**AMENDMENT TO
CONSTRUCTION CONTRACT
FOR CONSTRUCTION OF THE ALAMODOME IMPROVEMENTS PROJECT.
PROJECT NO: 45-00038
AMENDMENT NO. 1**

Project: 3422517-000 - Alamodome Final Four Renovations
100 Montana Street
San Antonio, Texas 78203

RFI #23: ASI #001 Clarifications

ASI Number: 001

Smooth Dowels in Existing Joints

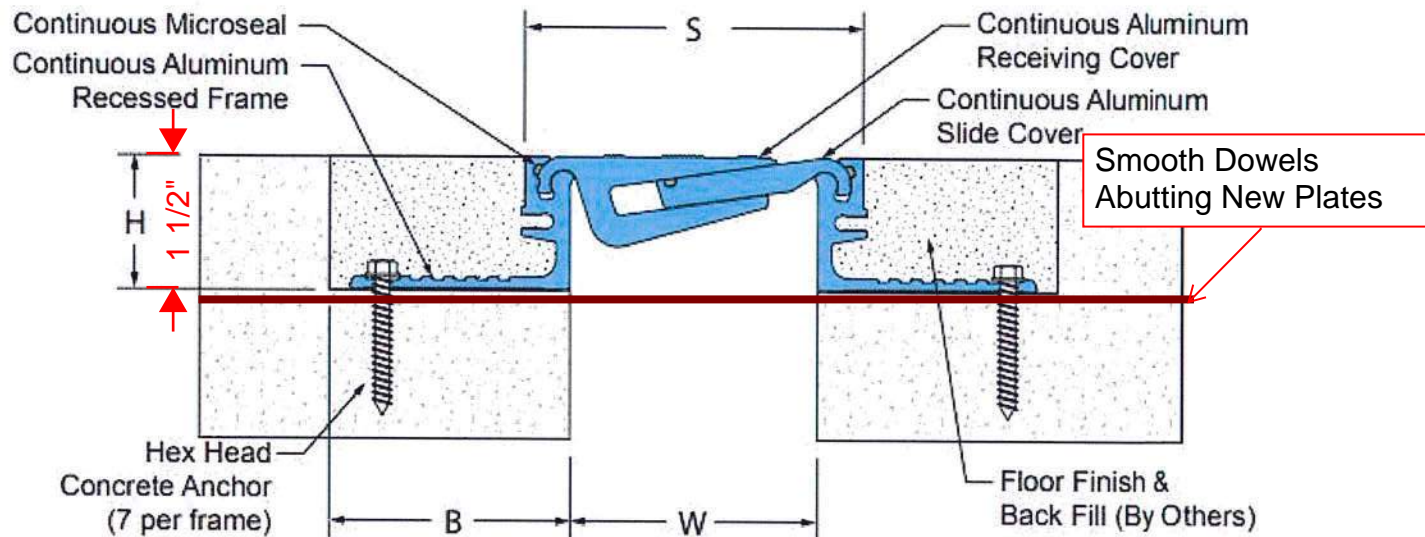
5. • There are smooth dowels in the slab with top of dowel at 1 1/2" BFF at the expansion joints. In areas where this condition applies, should the dowels be removed? (see page 6 & 7)

1. based on new expansion jt. selection, do not infill block-out at exp. jt.
2. correction on credit back on Exp. Jts. on club level. existing exp.jt. covers in concourse were to remain.
3. No. field level exp. Jt. to be redone.
4. The expansion Jt. product submitted is a bases of design. The specification in the documents does not apply for this work.
5. The dowels being referred to are conduits in the slab and should remain.
6. for this area of the exp. jt. we are using a different type of joint product ,which would be a neoprene in fill and sealant.
7. There is other similar covers as submitted with the vertical dimension being less than 1-1/2"

E1 OVERALL FLOOR PLAN - UPPER CONCOURSE LEVEL
1/32" = 1'-0"
0 8' 16' 32' 64' 96'

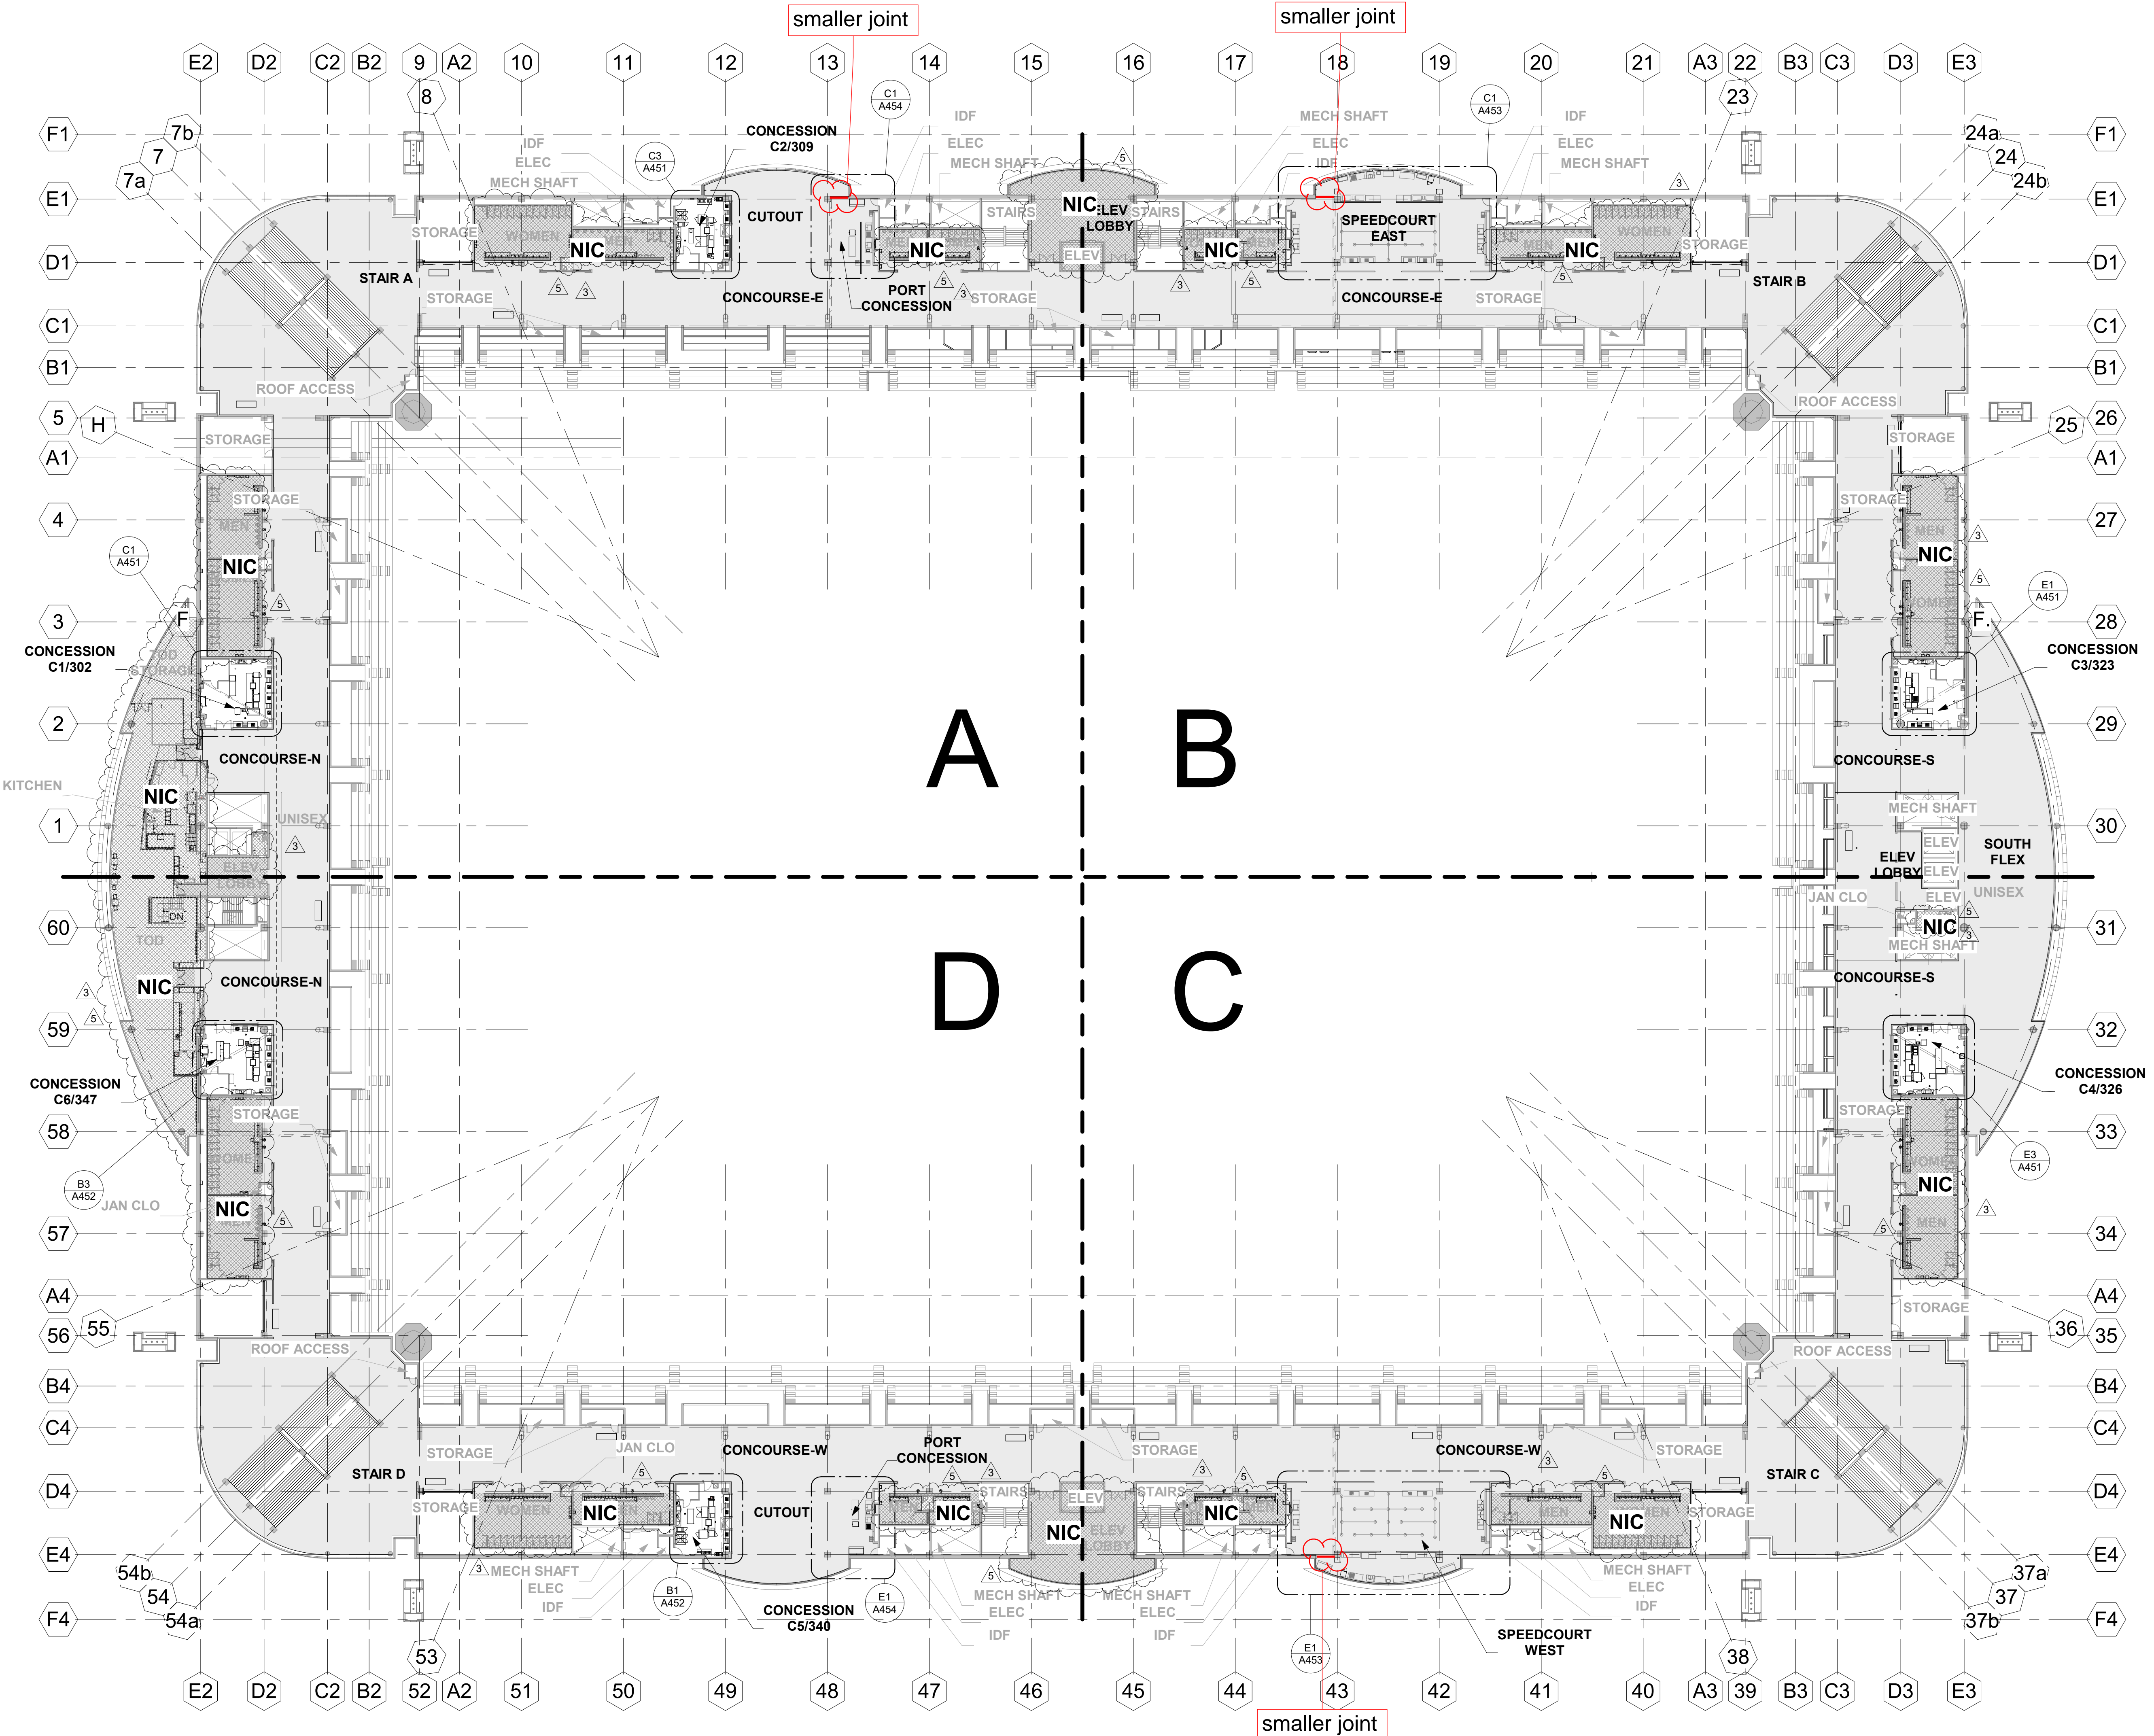
6. • ASI #001 calls out the joints returning to the wall along grid line E1 & E4 on Club and Upper concourse level. The current expansion joint does not have a block out or cover of any kind and is the width of the joint with a sealant infill. Please advise if these joints are to be demolished and the specified Inpro series system is to be installed or if they are to be left as is. (see pages 8, 9, and 10)

Contractor to provide New Expansion Joints cover at floor on all levels. There are eight (8) locations per floor. These expansion joint covers will be installed in concourse areas only as indicated on attached drawing.

E1 OVERALL FLOOR PLAN - CLUB LEVEL
1/32" = 1'-0"
0 8' 16' 32' 64' 96'
TRUE NORTH

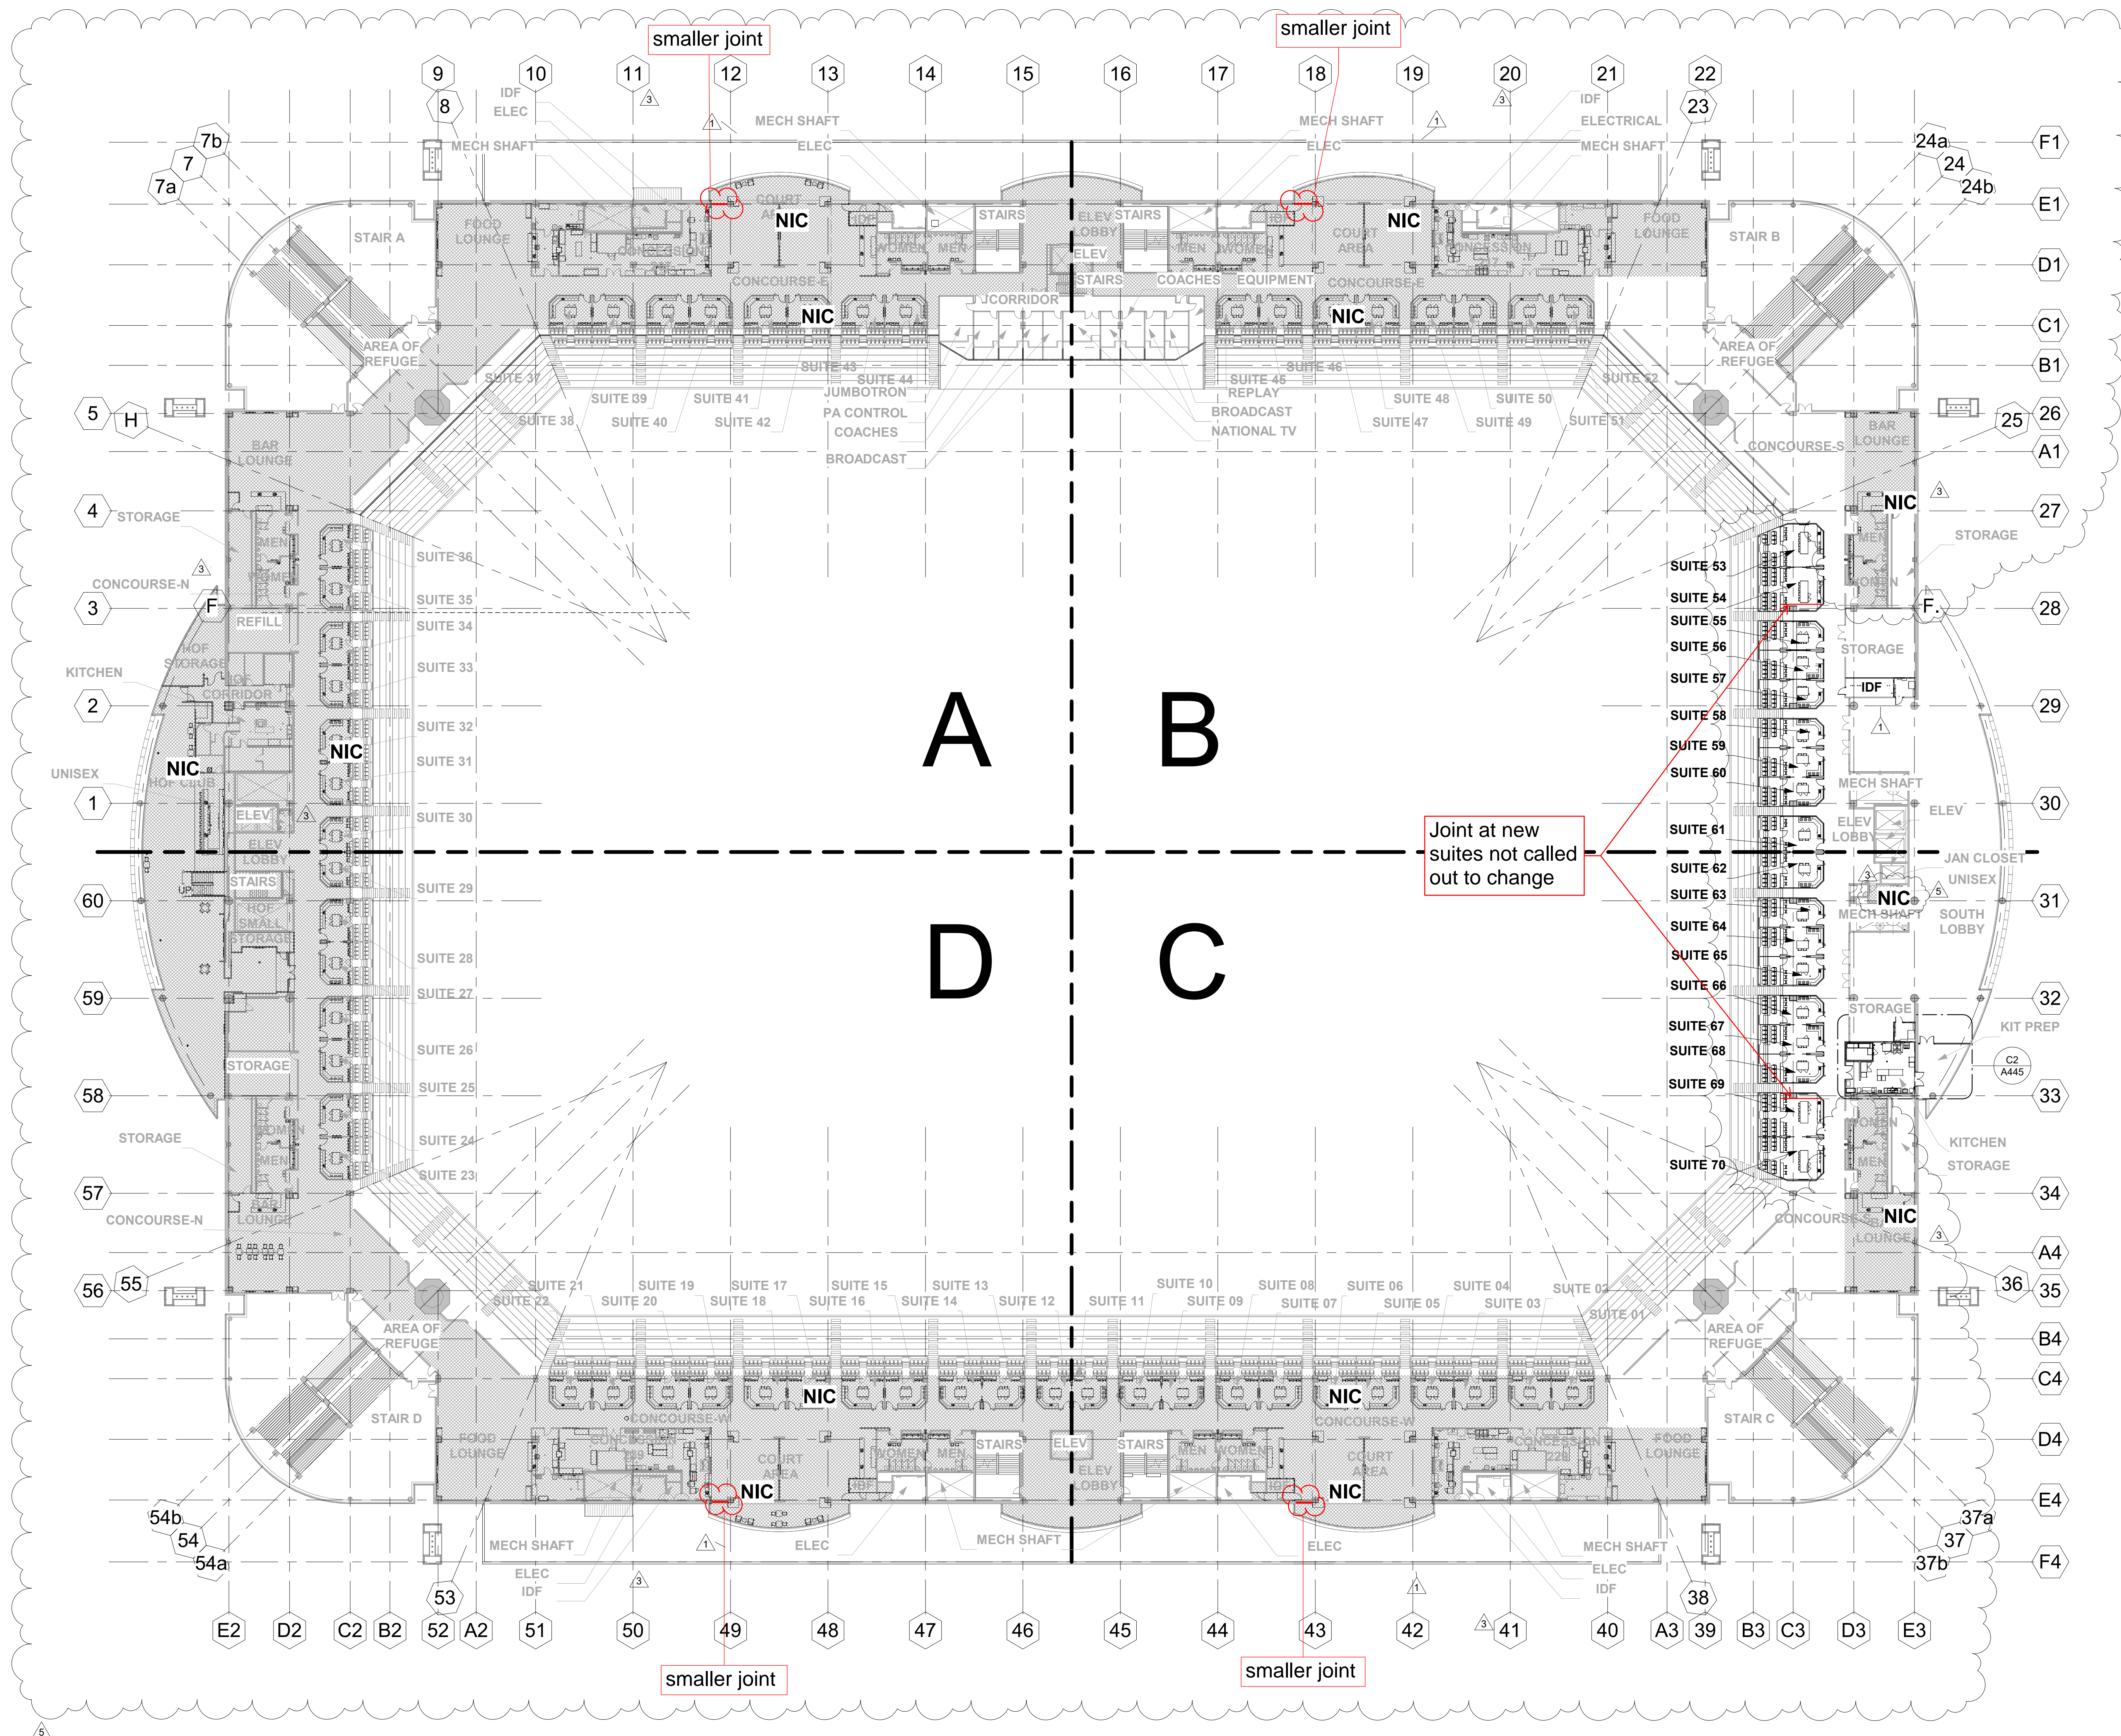
a. Contractor to provide credit back for 2 locations on club level, detail C4/A961

E1 OVERALL FLOOR PLAN - FIELD LEVEL

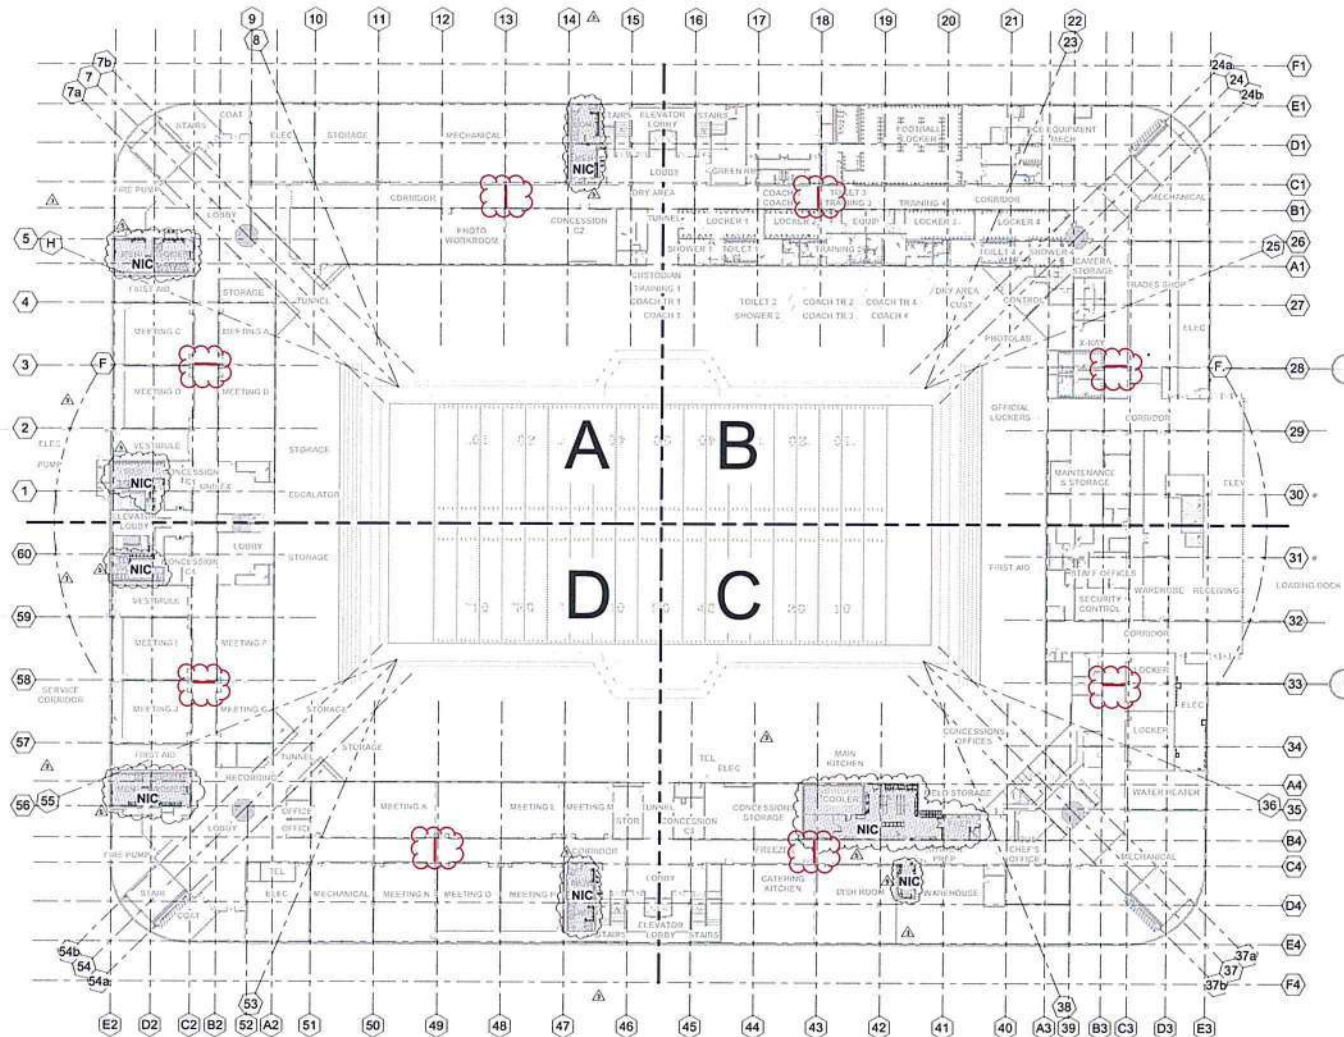
3. • Please confirm the construction joints called out on field level are no longer in scope of ASI #001. (see pages 2 & 3)
4. • The expansion joint product specified in the ASI does not meet the movement capabilities called out in specification 079500. Please advise if movements +/- 25% is acceptable. (see pages 4 & 5)
